Project: Esplanade Curtain Wall Repairs **Date:** November 20, 2018
RE: Addendum #1
of Pages: 4

The following information is provided in response to specific questions received by BPCA in connection with the Esplanade Curtain Wall Repairs Project RFP. The submitted questions were either posed at the pre-proposal conference held on November 8, 2018 or received in writing by close of business on November 14, 2018.

BATTERY PARK CITY
ESPLANADE REPAIRS
NEW YORK
NEW YORK

A TYPICAL EXISTING ESPLANADE SECTION
S-6.0

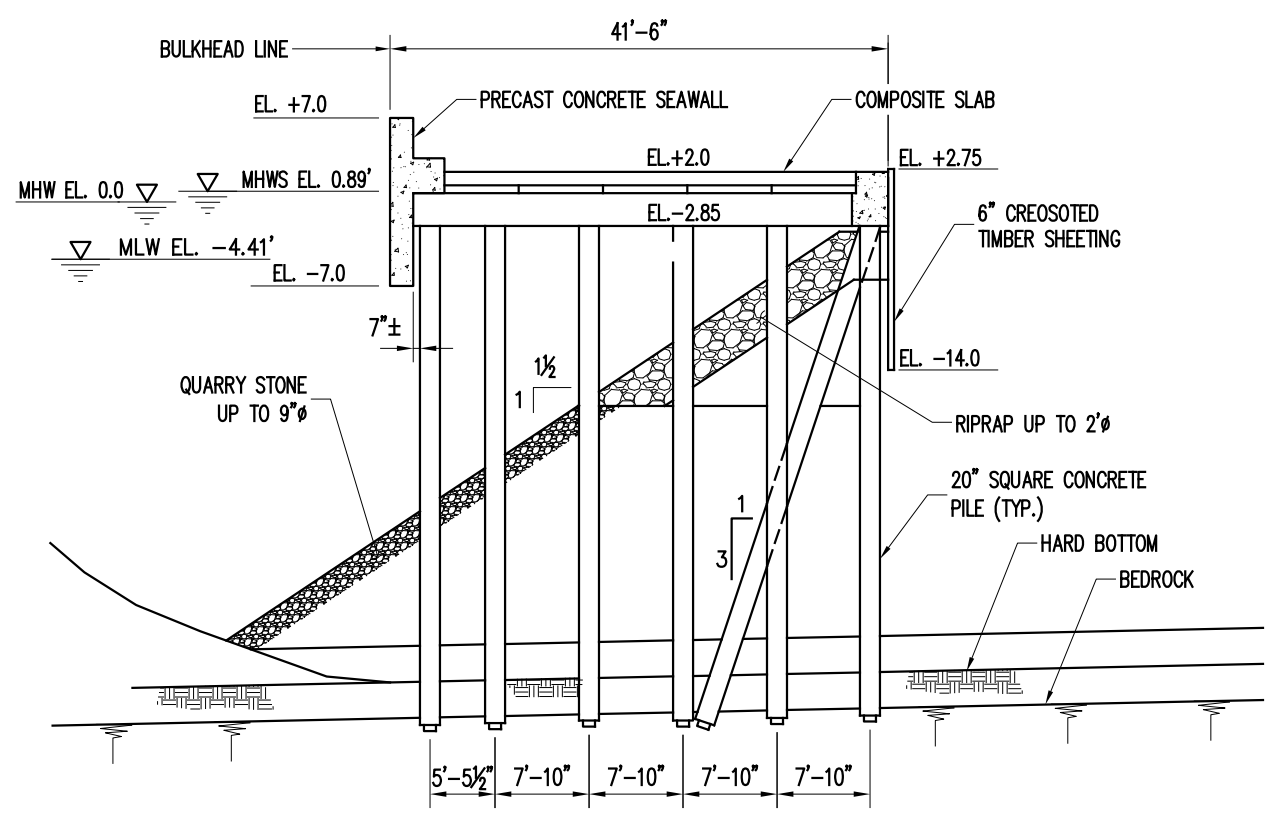
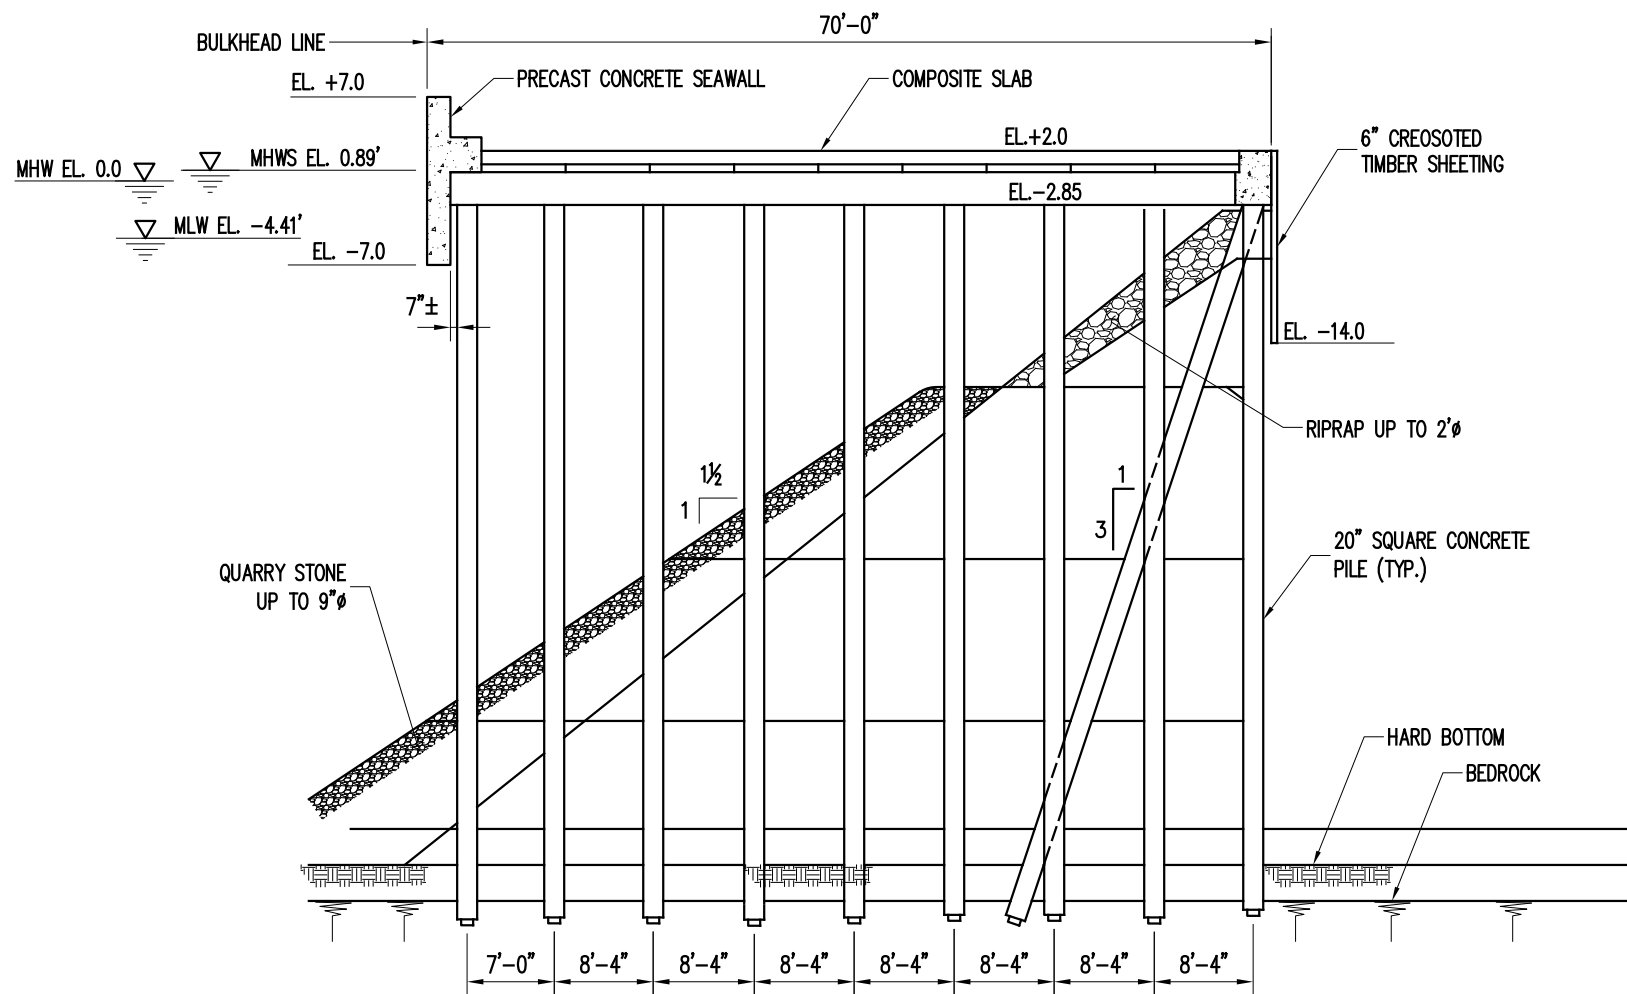
- 6) Is there a detail available regarding the existing expansion joints?

- 7) The Vertical Wall Spall Repair doesn't show where MLLW or MHW, are the repairs in the tidal zone? Can the engineer provide a cross-section of the curtain wall?

RESPONSE: *A detail of the existing joint is not available. The expectation for the repair is to remove existing joint and replace with a new 2” x 4” joint per the notes. Joints are vertical and span the entire height of the curtain wall (14’) and are approximately 2” wide and 1’3” deep. This is illustrated in the attached section included as a response to number 7.*

RESPONSE: *See attached typical section of the curtain wall. While some repairs are above mean high water (MHW), a portion of the repairs are in the tidal zone and a portion are below mean low water (MLW).*
